Shoreland Permit Applicationfor a **Shoreland Protection Permit** under
Chapter 49A of Title 10, § 1441 *et seq.***For Shoreland Permitting Use Only**

MCNERNEY RESIDENCE

Application #263

RE: Revisions to Project Description

McNerney Residence
Existing Conditions and Demolition

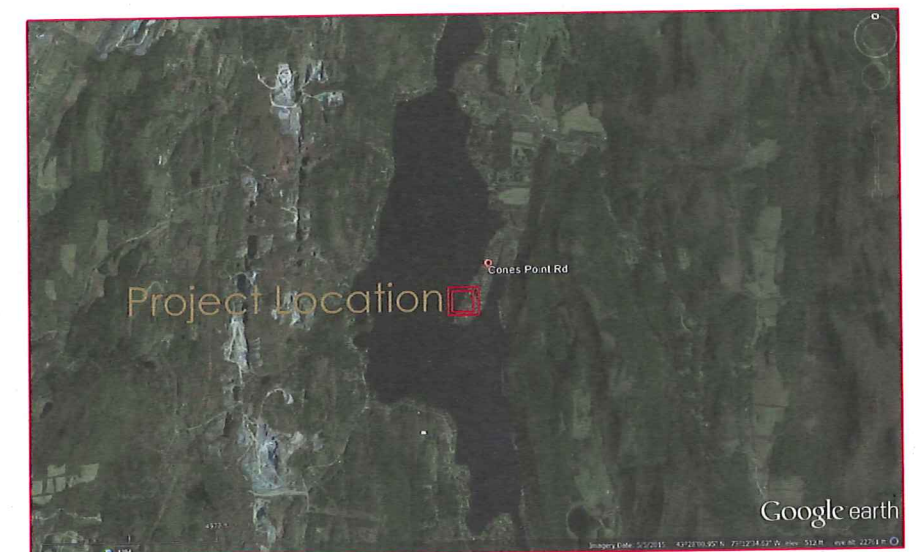
MCNERNEY ↓ EXISTING STEPS TO BE REMOVED.

MCNERNEY ↓ VEGETATED SLOPE TO BE REINFORCED & REPLANTED.

McNARYWAY ↓ EXISTING DECK TO BE REMOVED.

McNARYWAY ↓ CONCRETE FOOTER, IN LAKE, EXISTING, TO BE REMOVED.

McNerney Residence
PROJECT OVERVIEW

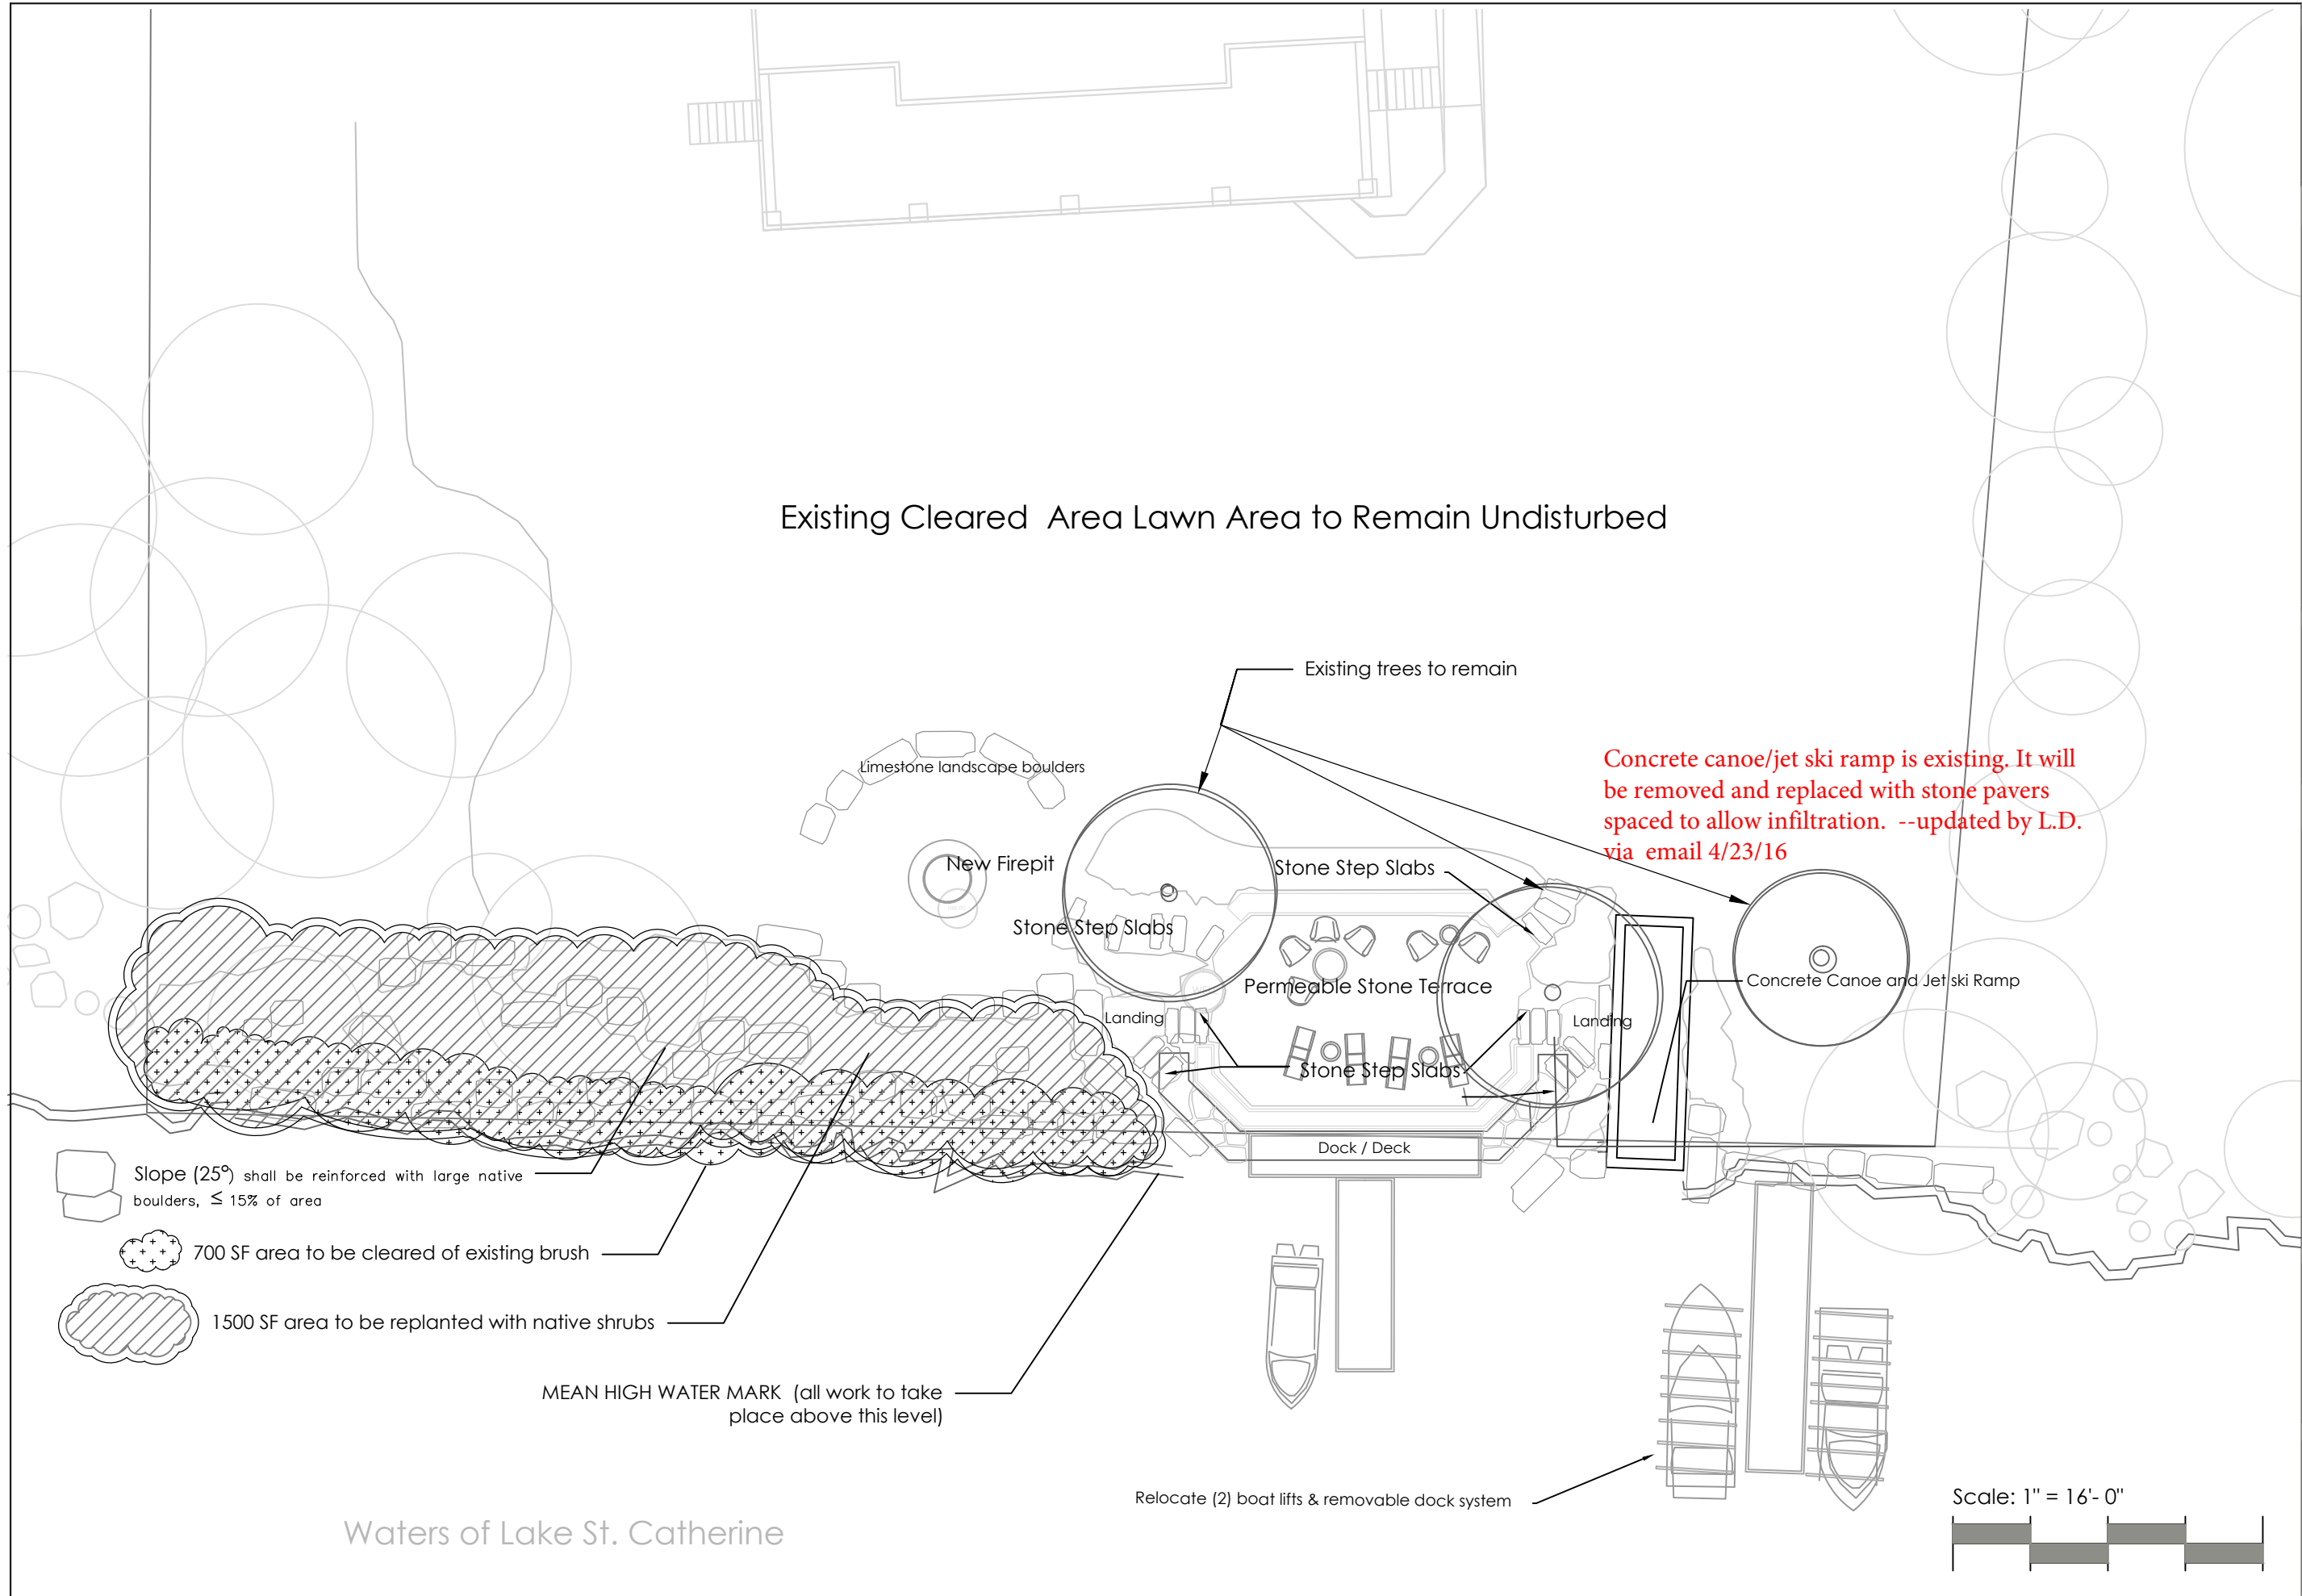
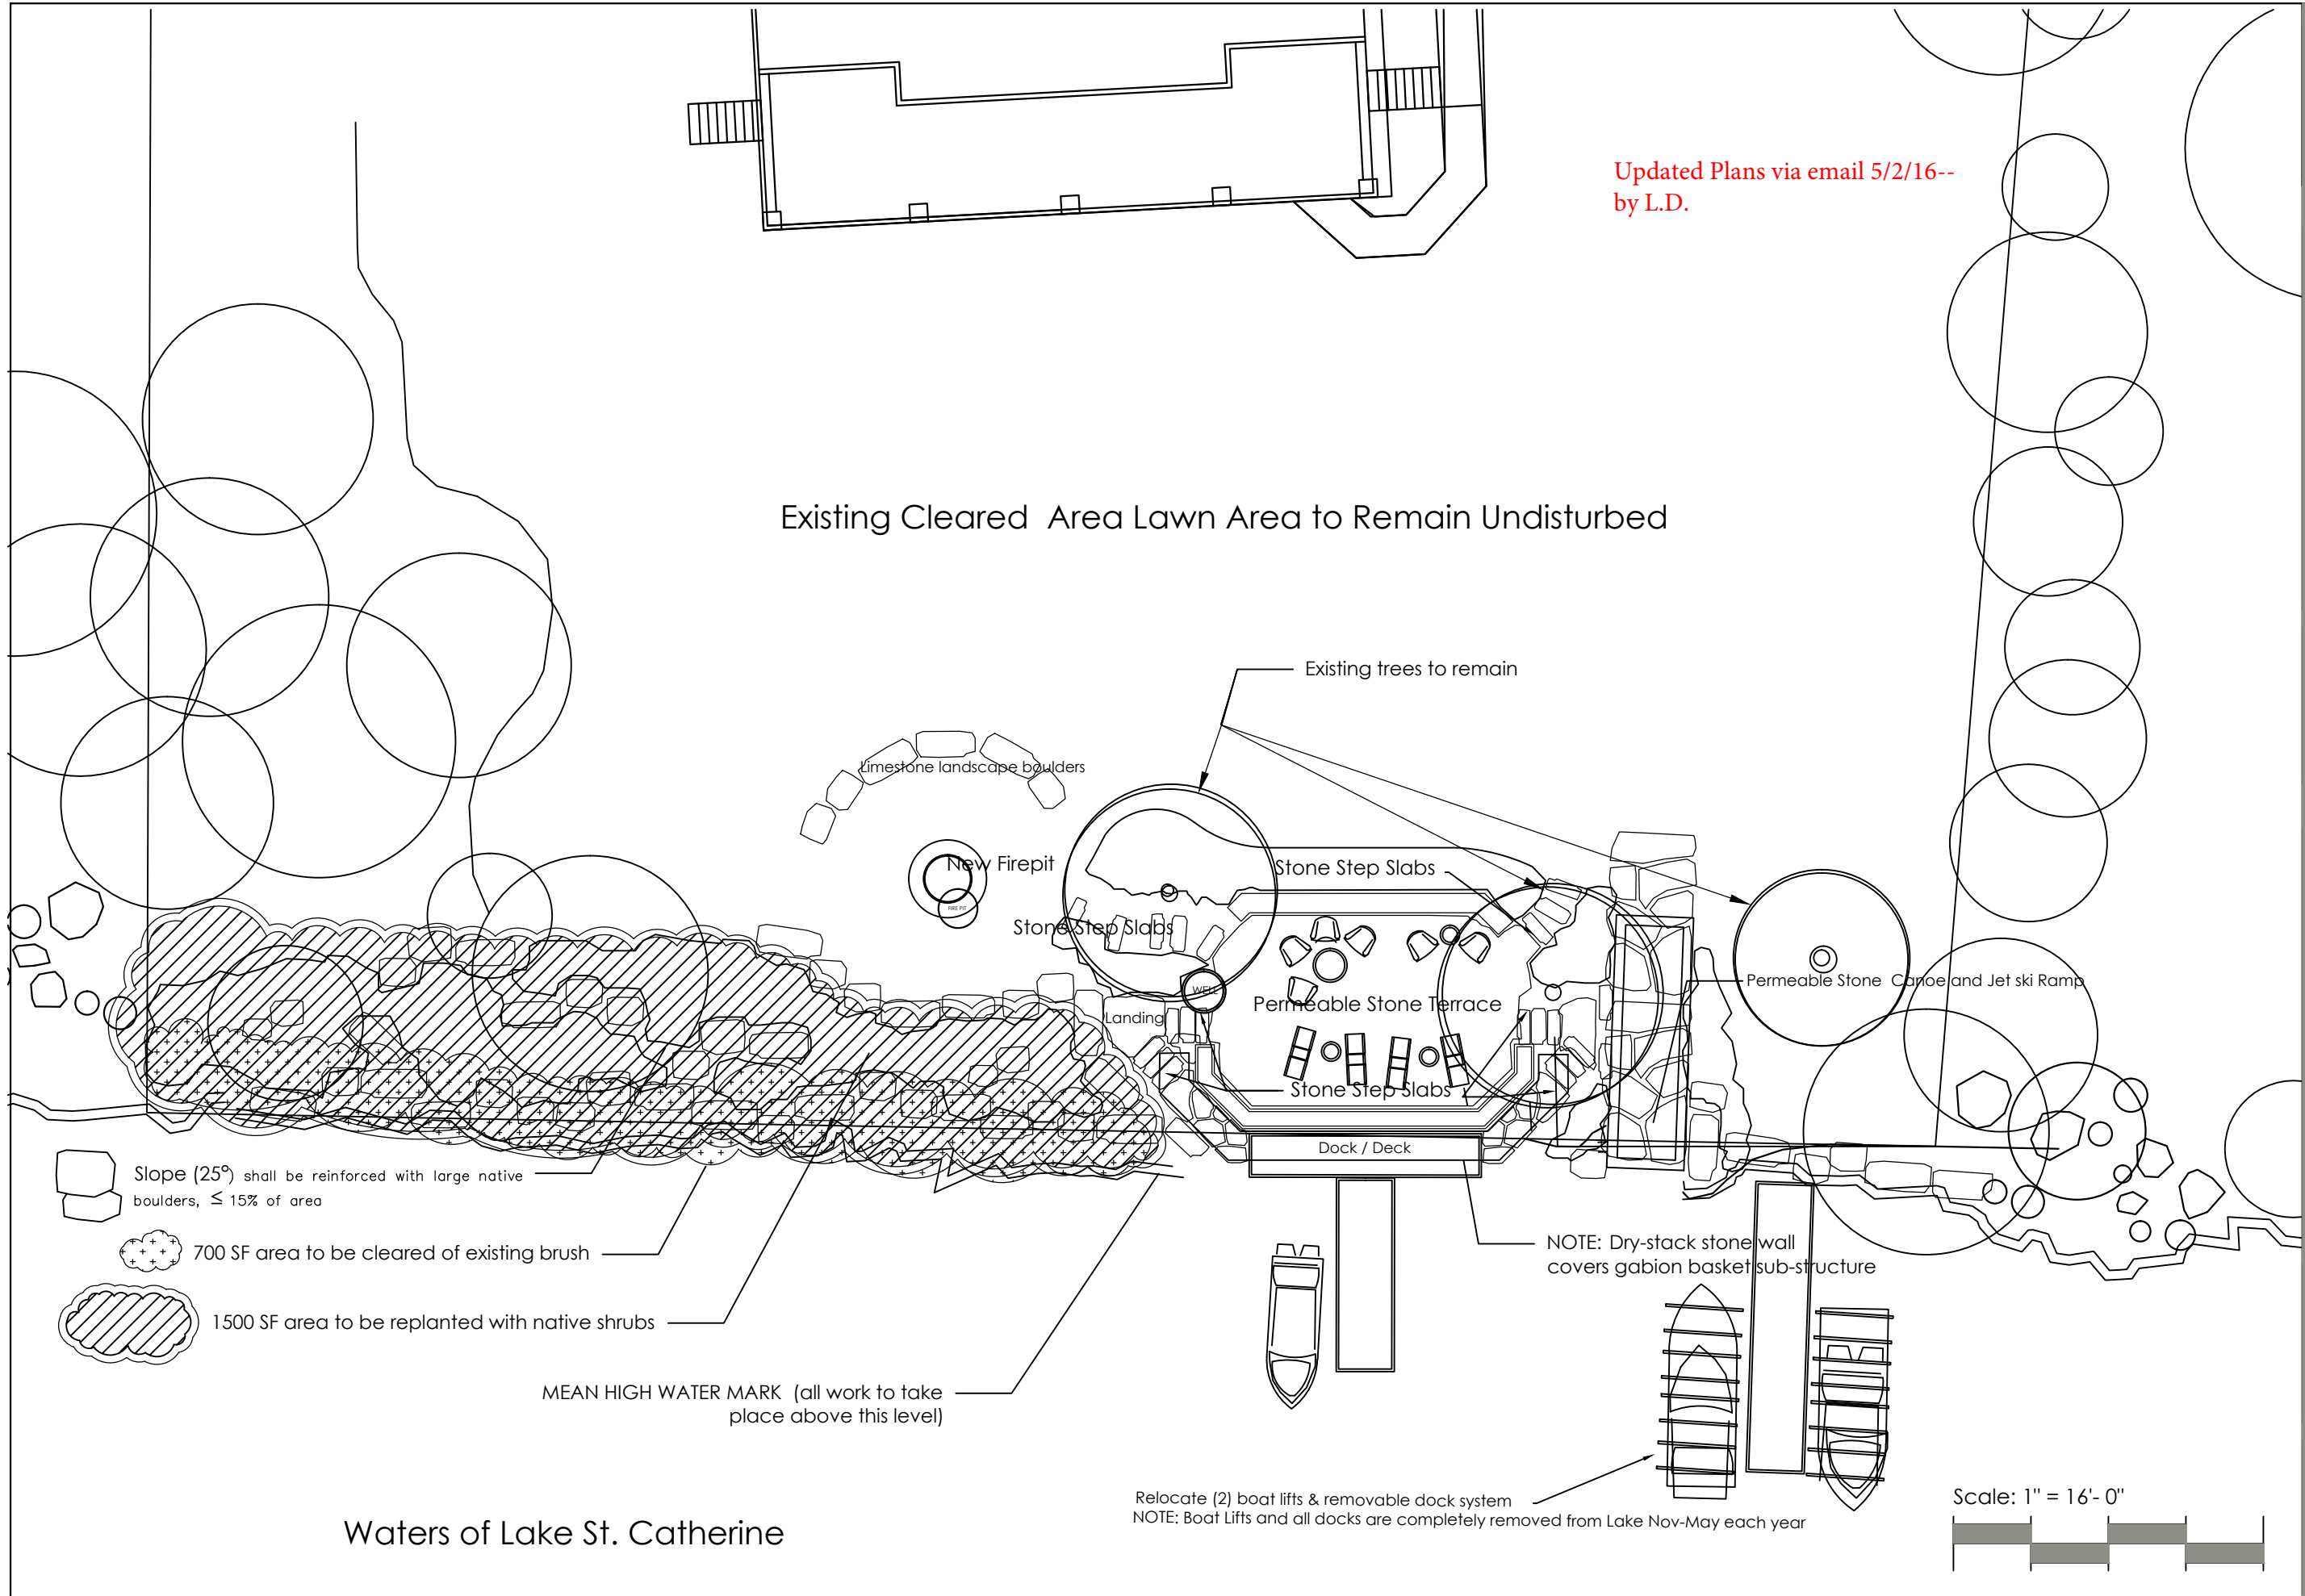
Please note the following revisions and clarifications to the Project Description in light of our site meeting with Laura Dlugolecki on April 6th.

2. We propose to clear and replant using best management practice, a small area along the shoreline, specifically:
 - Clear an area of 700 SF; consisting of Red Twig Dogwood shrubs, basswood seedlings, and alder seedlings. Cleared area will be replaced with 1400 SF of replacement plantings, at an approximate density of one plant per 20 SF. Replacement planting mix shall be composed native shrubs, including dwarf red twig dogwood, fragrant sumac, and potentilla. Plantings shall be mulched with hardwood mulch to hold moisture and prevent erosion during establishment. See attached revised project drawing.

3. We propose to stabilize the slope, which is over 20 degrees, using best management practice method of:
 - Place large local natural stone boulders, in natural appearing groups and arrangements on the slope, to strengthen the slope, and create an indigenous rocky slope appearance. Total boulder area shall not exceed 15% of total slope area. Plantings will be placed around and adjacent to boulders.

4. We propose other changes to the cleared area, including replacing a decayed deck and concrete wall system with permeable patio and permeable wall system, as shown in the site plan presented with the original permit application.

Updated Plans via email 5/2/16--
by L.D.

Slope (25°) shall be reinforced with large native boulders, ≤ 15% of area

700 SF area to be cleared of existing brush

1500 SF area to be replanted with native shrubs

MEAN HIGH WATER MARK (all work to take place above this level)
